**RE: March 2016 Board Update**

## Change Order

**CHANGE ORDER NUMBER:** 014

**MPE REQUEST FOR PROPOSAL**

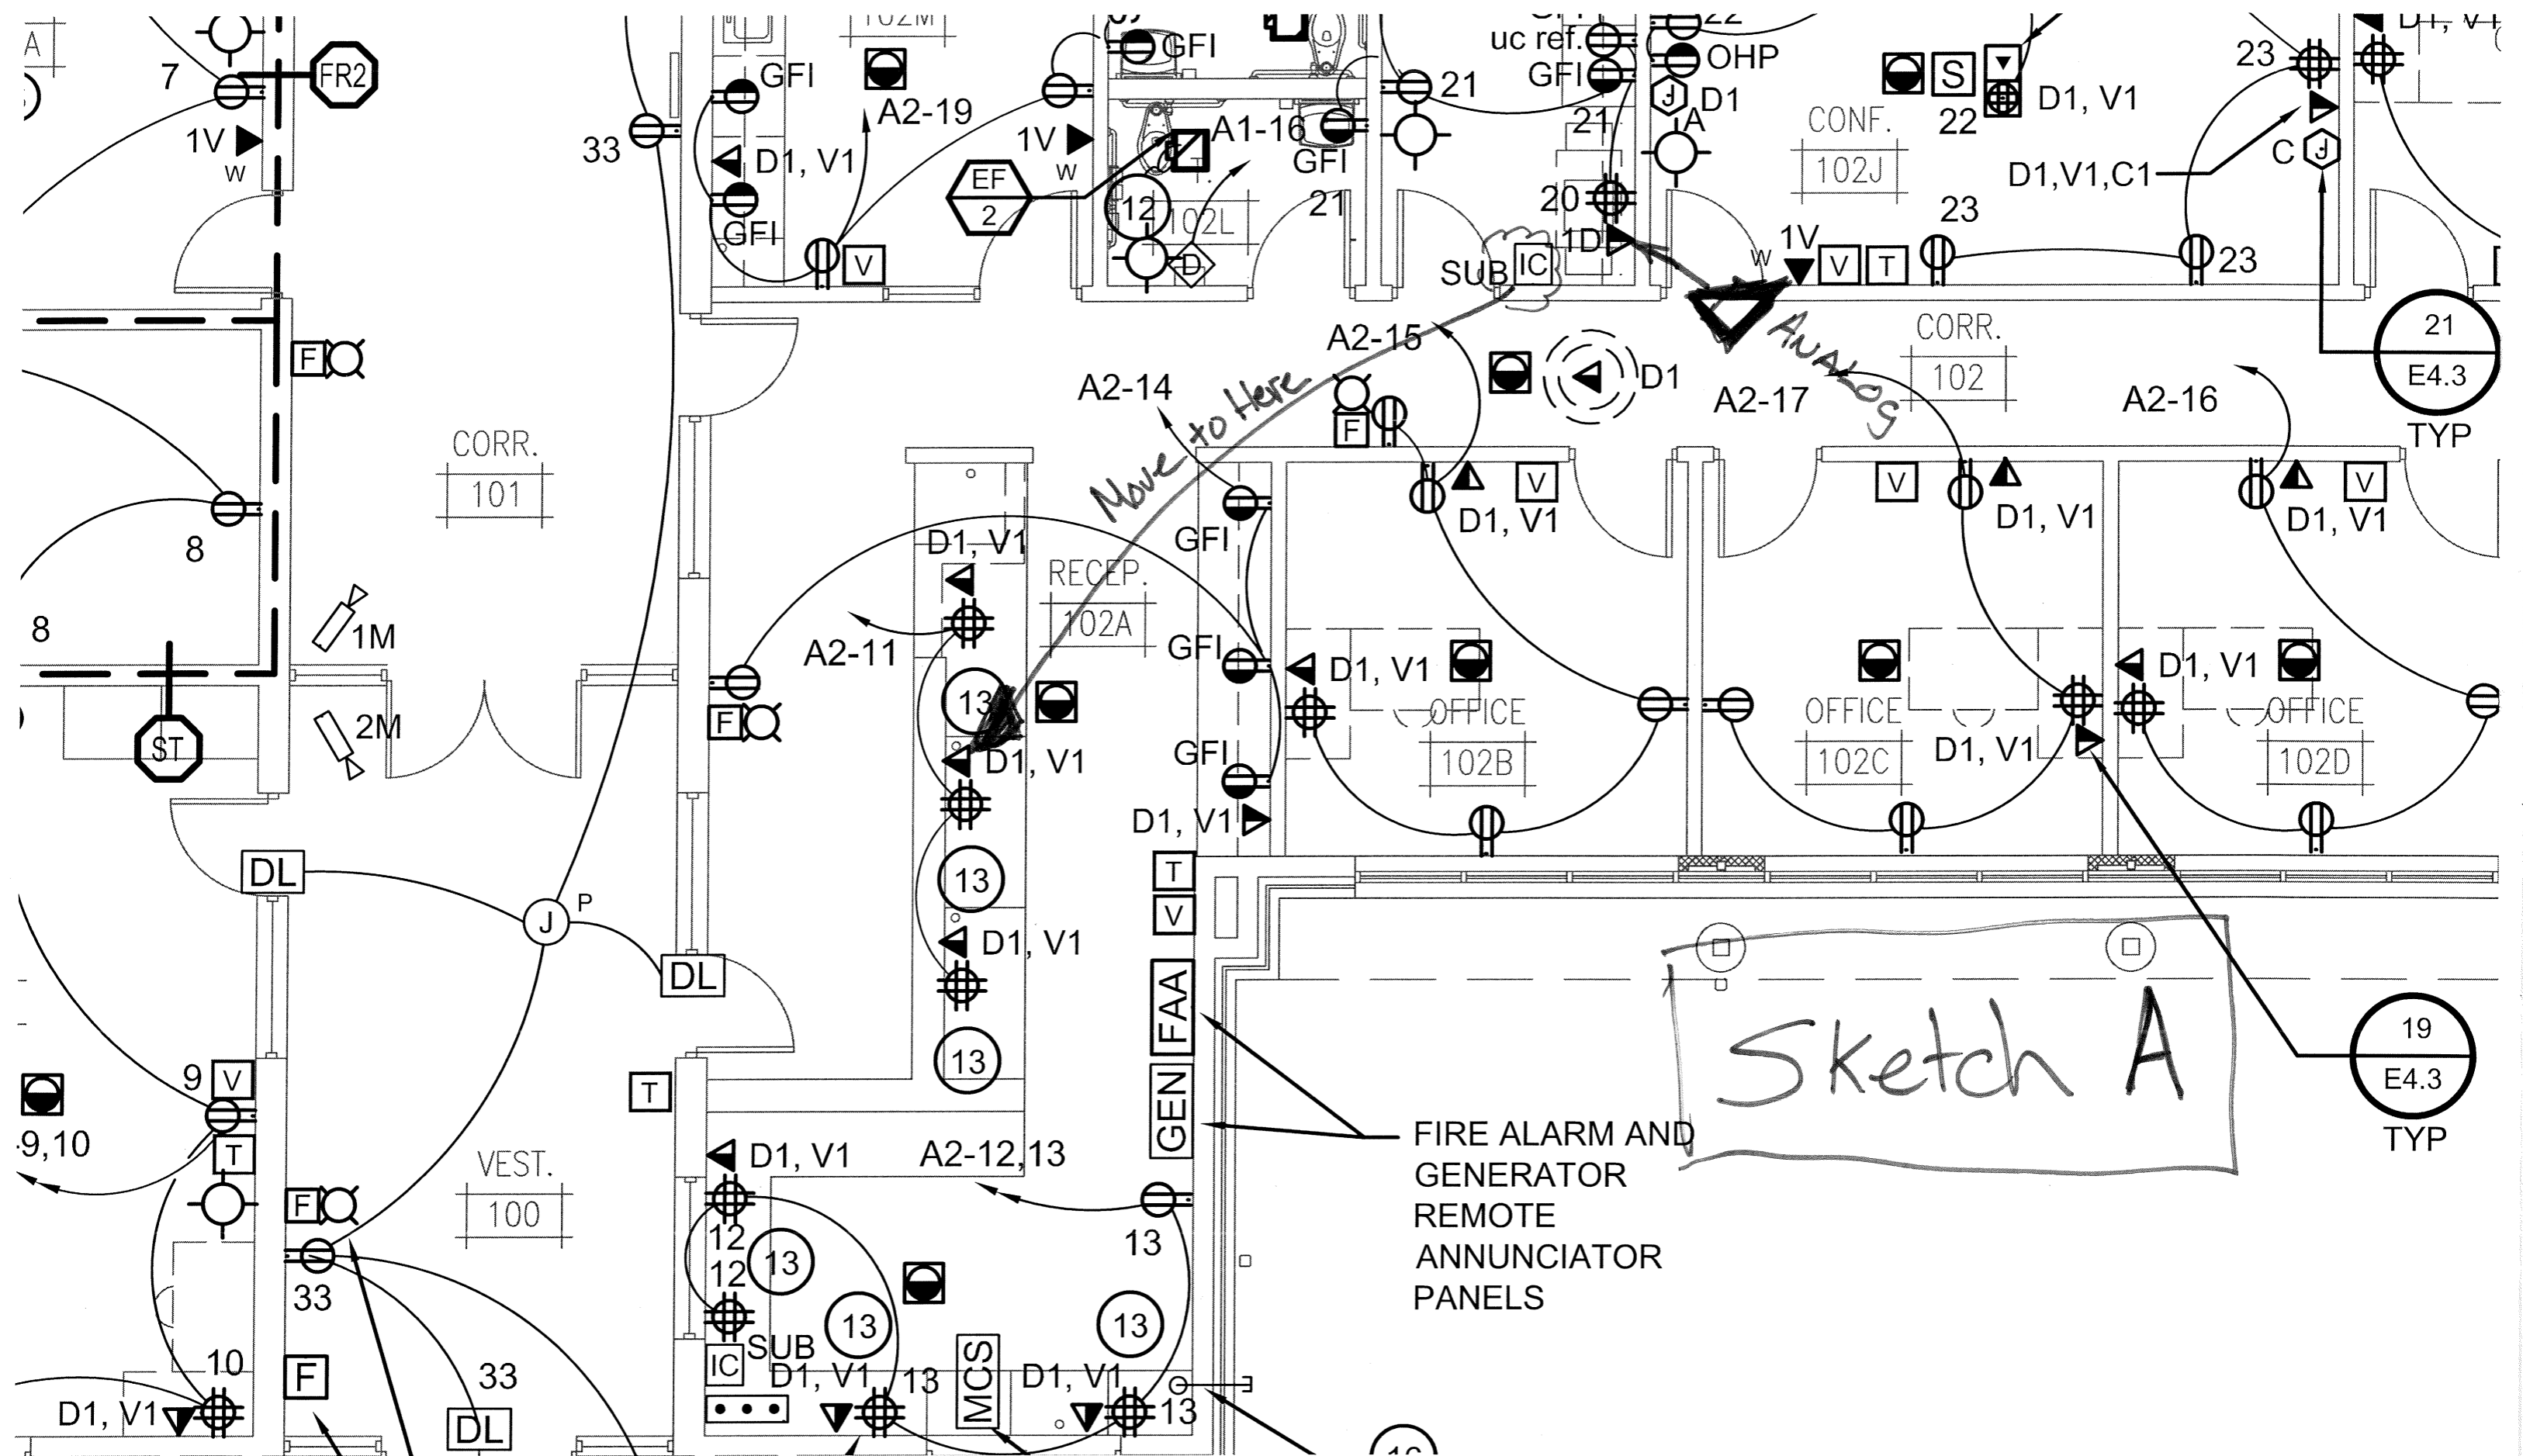
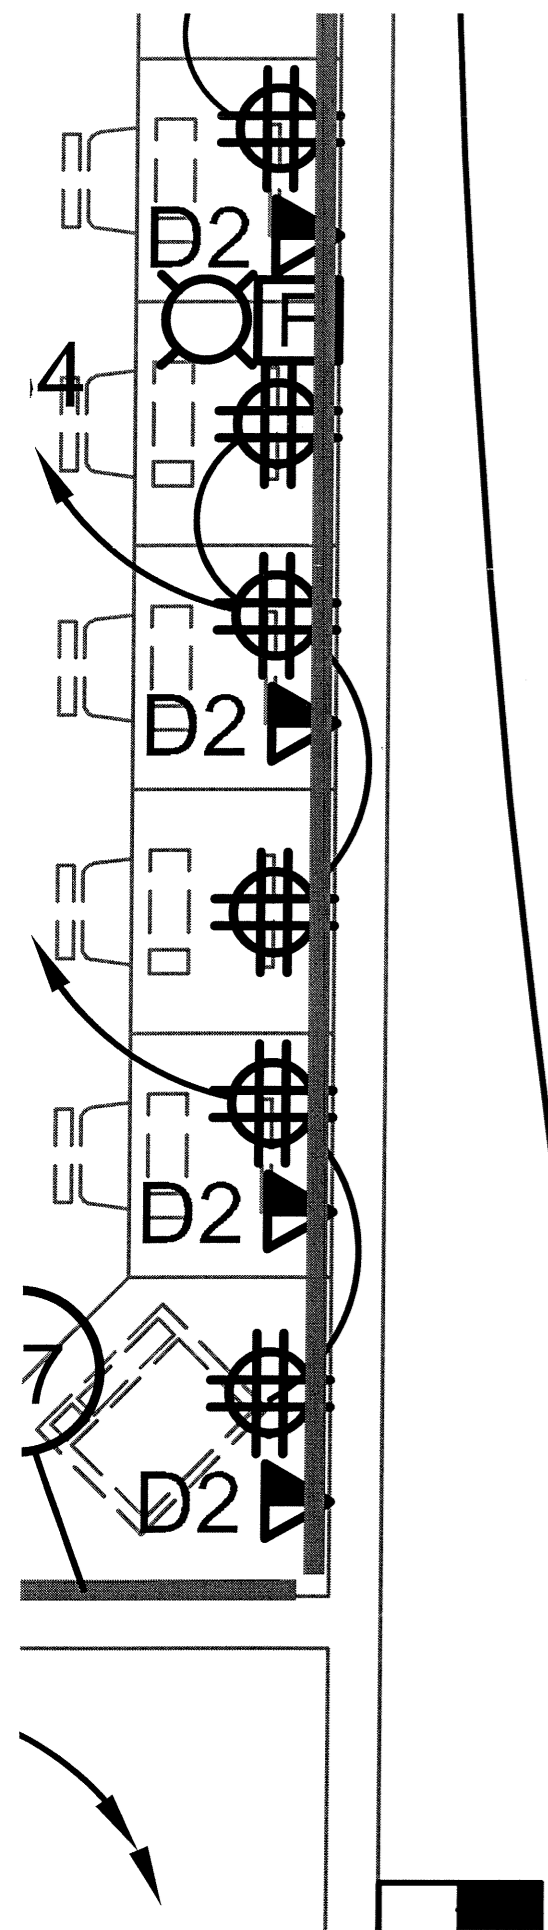
Item #5: Voice /Data Connections – Office Workroom 207A/Staff Workroom 209 – Refer to Sketch C.

- Data outlet and jack located adjacent to the sink in Workroom 207A shall be repurposed to serve Workroom 209, by means of a through wall penetration. Drill through wall and back of j-box to penetrate into Room 209. Furnish and install a ½" conduit nipple through wall and terminate into a surface mounted Wiremold j-box on the South wall face of Workroom 209. Pull existing cabling drop through wall and re-terminate existing jack in new j-box and re-install existing coverplate. Abandoned j-box in Workroom 207A shall be blanked off.

- Furnish, install, terminate and test (1) one voice and (1) one data cable drop at Northeast corner of Workroom 209 as indicated on Sketch. Voice drop shall be located on North wall and Data drop shall be located on East wall. 700 Series Wiremold Raceway shall drop in the void space of the upper cabinets, tee at bottom of cabinet and extend to location of new jacks. J-boxes for jacks shall be Wiremold single gang boxes, mounted horizontally. Surface mounted raceway shall be mounted at bottom elevation of upper cabinets, high as possible. Paint exposed raceway to match adjacent surface.

Sketch B

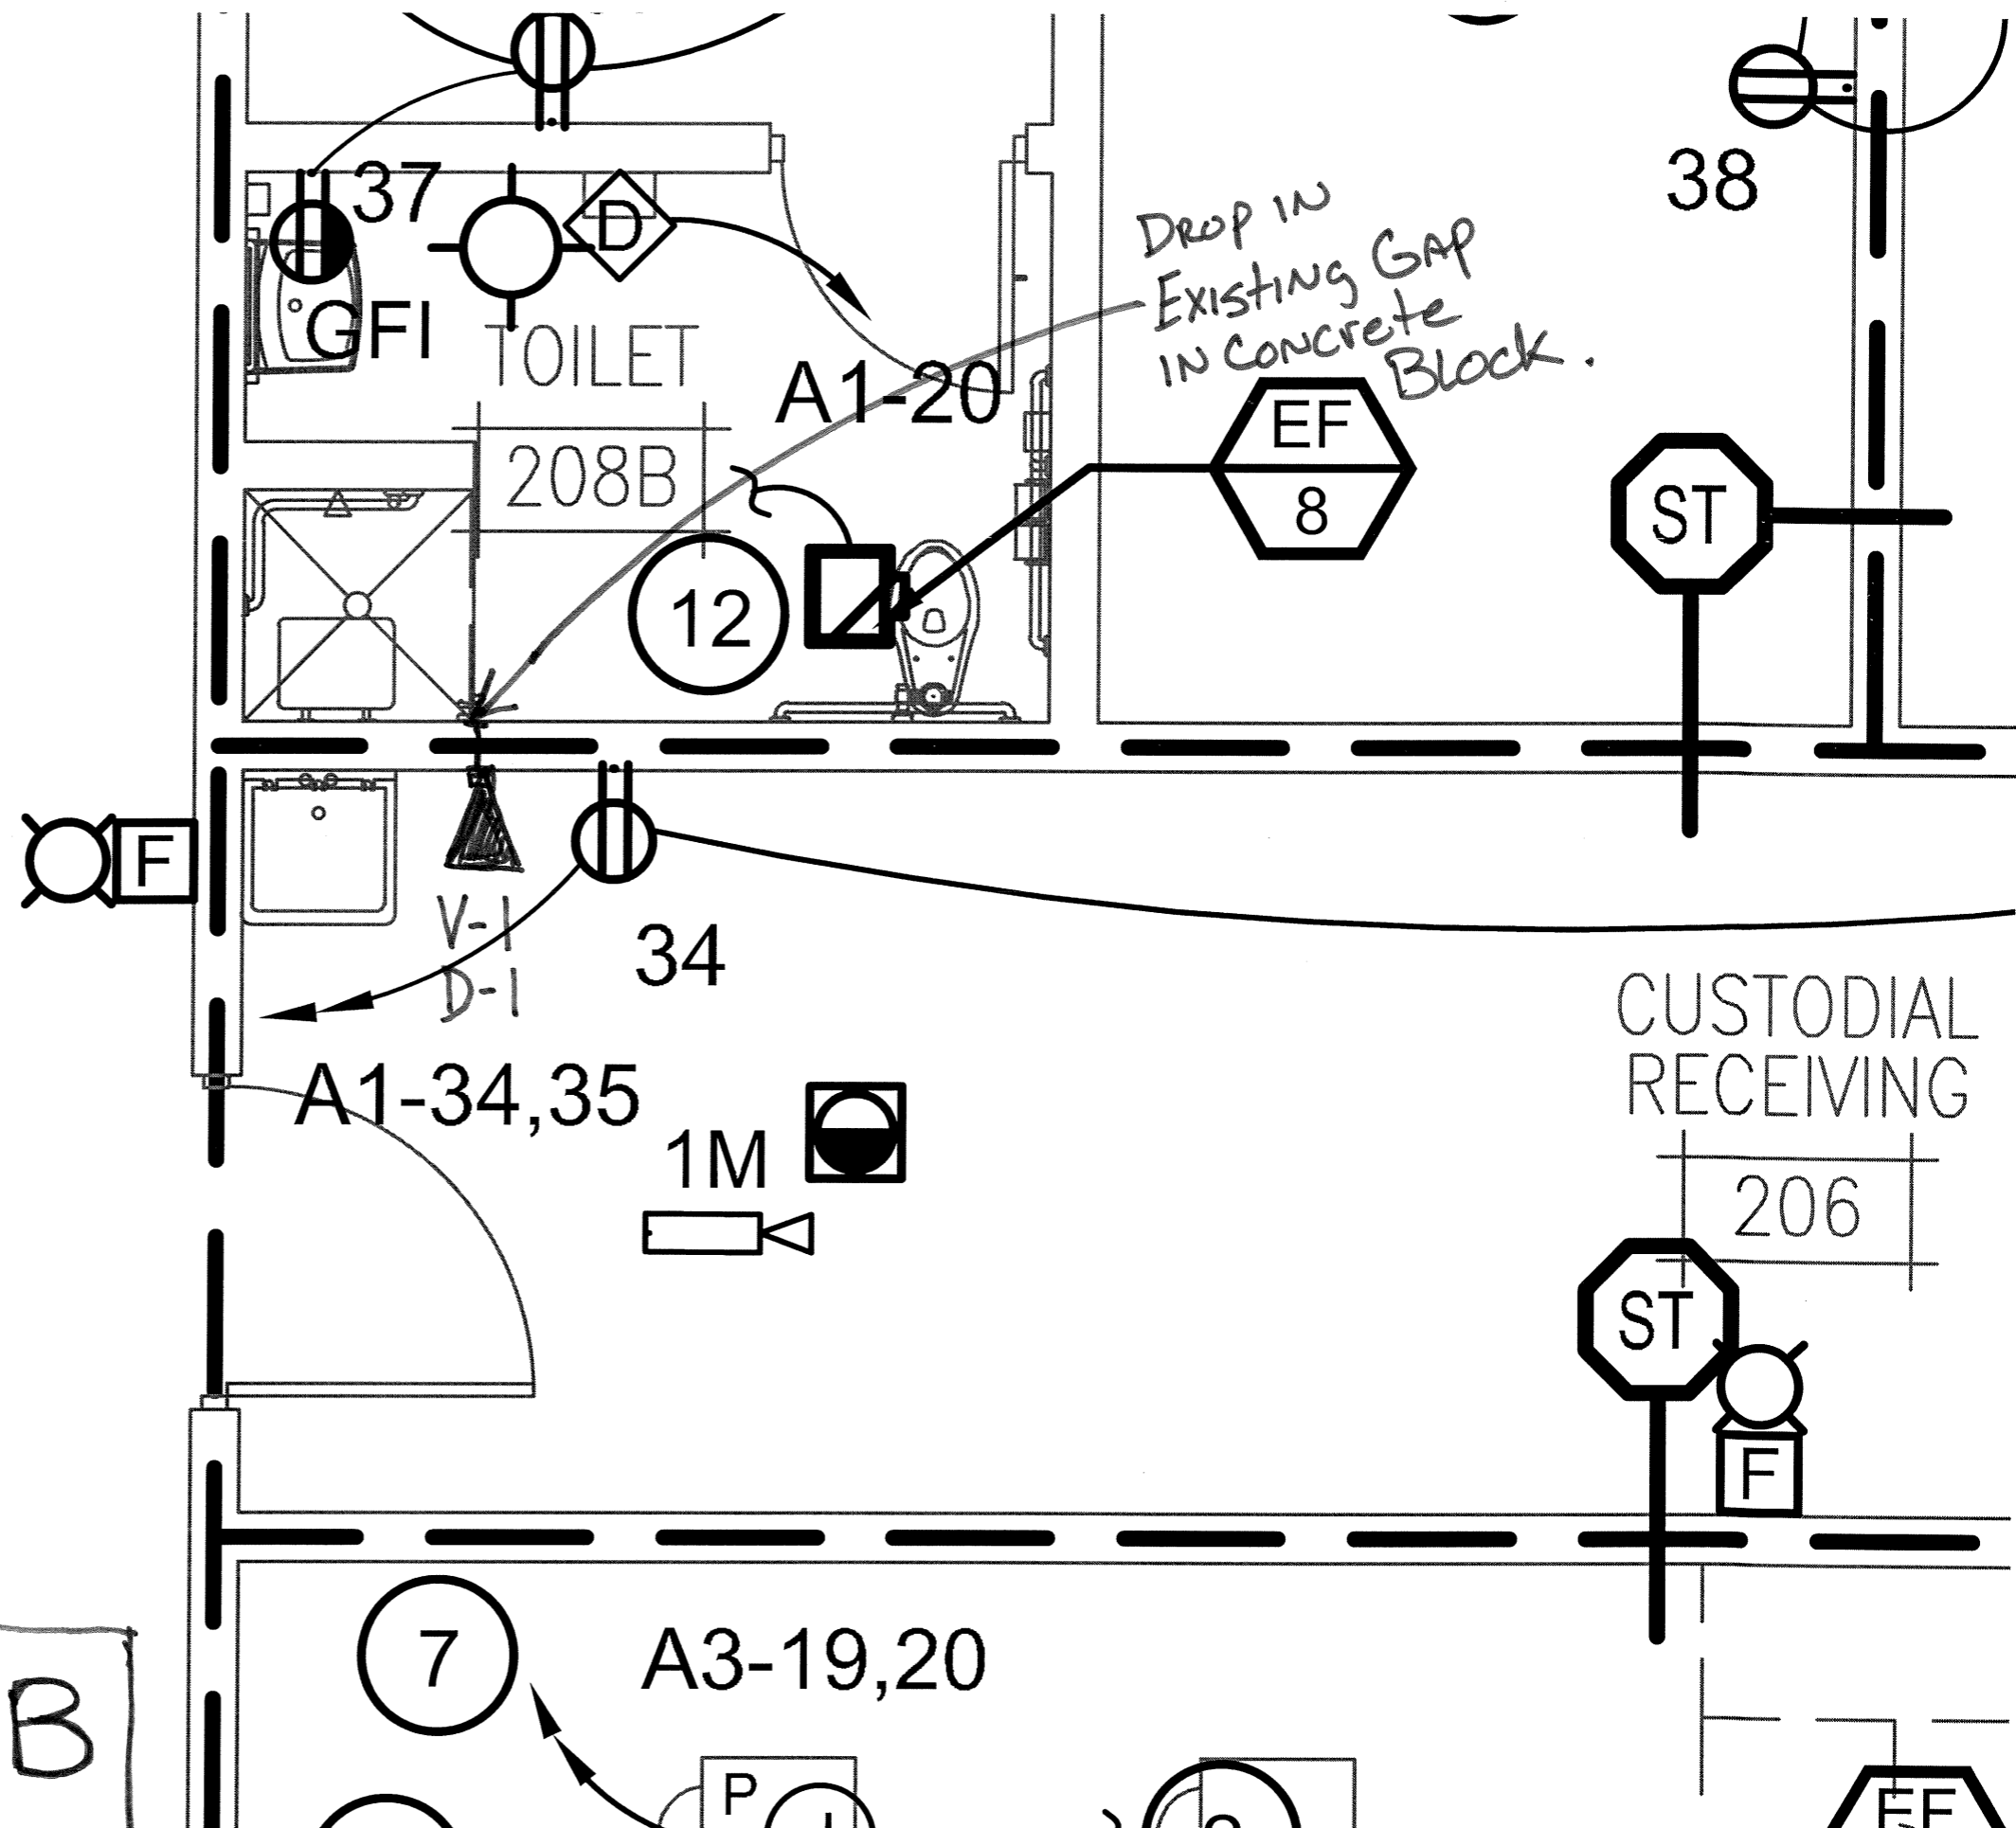
Item #4: Voice/Data Connections – Custodial Receiving 206 – Refer to Sketch B.

Furnish, install, terminate and test (1) one voice and (1) one data cable drop at 16" a.f.f. Conduit drop shall be concealed by dropping in soffit area of Shower in Toilet 208B and routed in existing gap in concrete block, adjacent to shower stall and penetrate through wall and terminate in a surface mounted single gang Wiremold j-box. Furnish and install double port coverplate and label. Opening along shower will be concealed by shower trim.
